Reference: Engineering Services
447 Deanne Lane
Coats, NC 27521
TE&D Project No.: 1901-020458_A

As requested by the client, a representative of Tyndall Engineering & Design, PA (TE&D) was on-site to provide analysis for the following item(s):

- 1) Structural assessment of the first-floor framing within the crawlspace.

Item #1B:
Install 2 x 10 Blocking at 16" o.c.

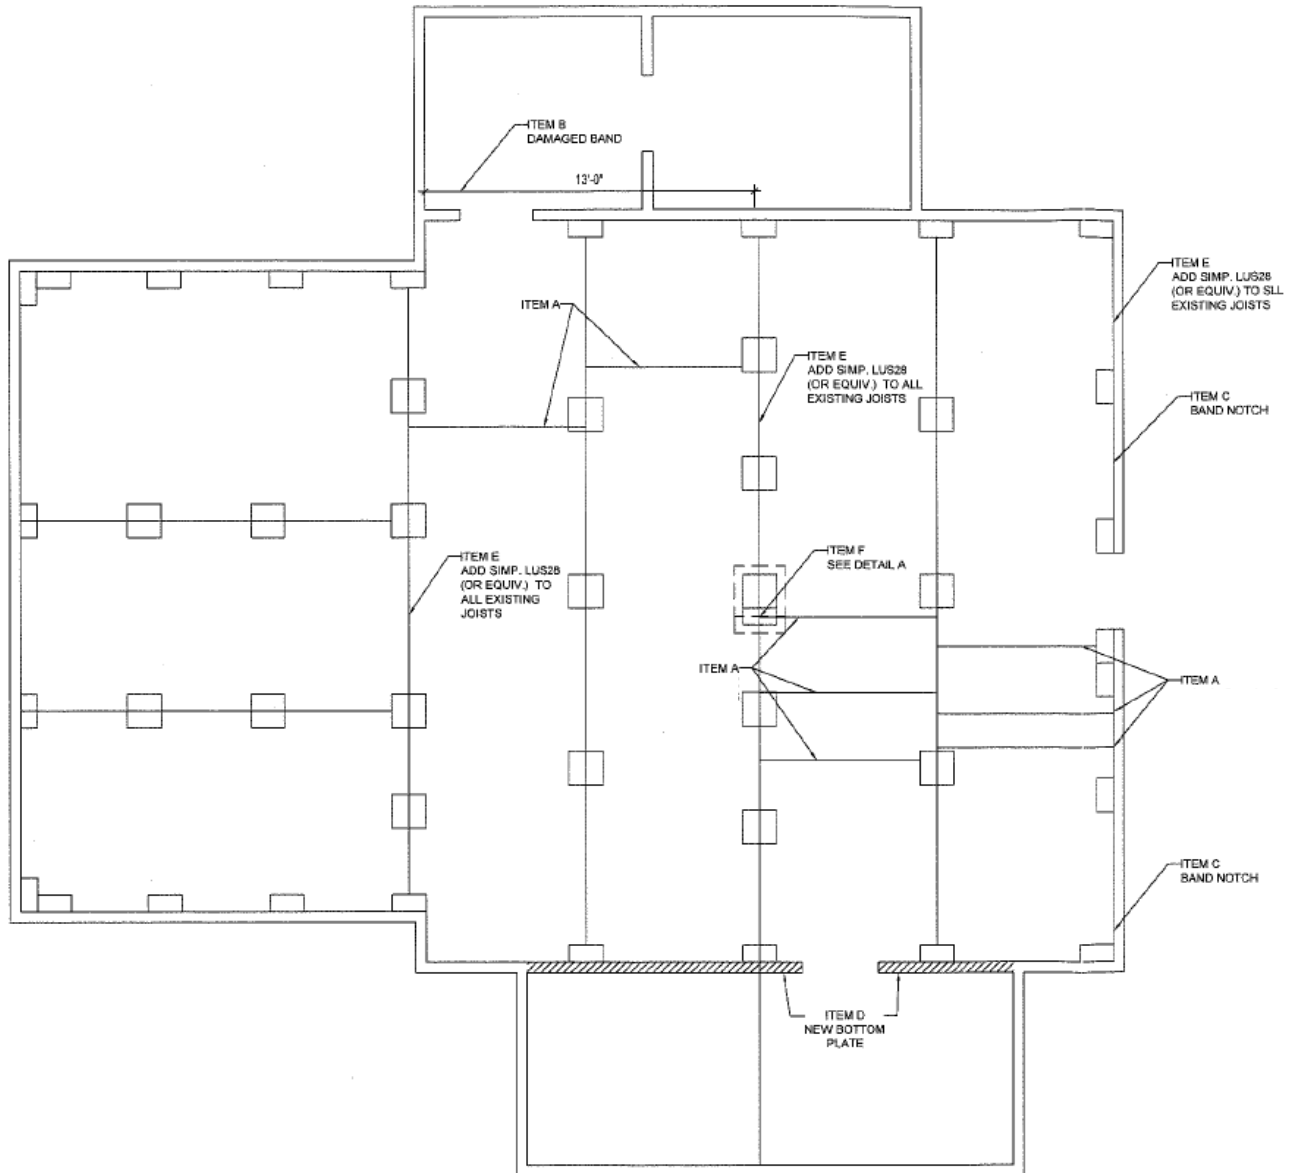
- B) Approximately 13'-0" of the 2 x 8 band at the rear of the house was observed to be damaged. Based on our observations and analysis, the band is to be reinforced with 2 x 10 blocking installed vertically at 16" o.c. Blocking is to be secured to the exterior deck band with 5/8" diameter through bolts. A (2) 2 x 8 header is to be installed over the crawlspace opening.

Install (2) 2 x 8 header over crawl opening

NTS  DETAIL "A"

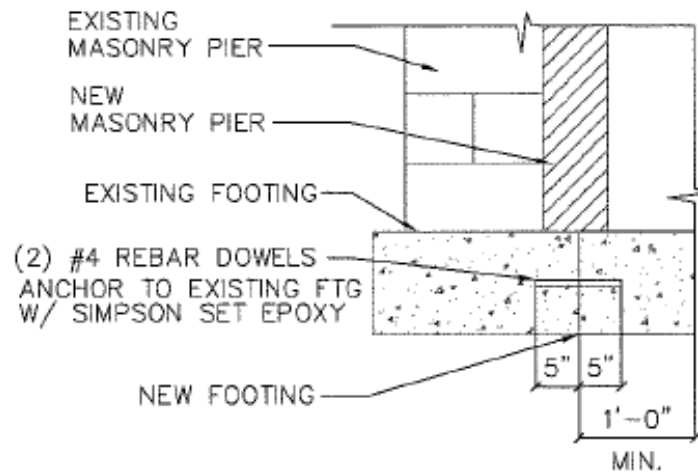
- F) An unsupported splice was observed in the second girder from the right. A new 8 x 16 CMU block pier is to be installed below the splice. The new pier is to have full bearing on a new, minimum 12" x 20" x 10" poured concrete footing. (see plan for location and detail A for installation)
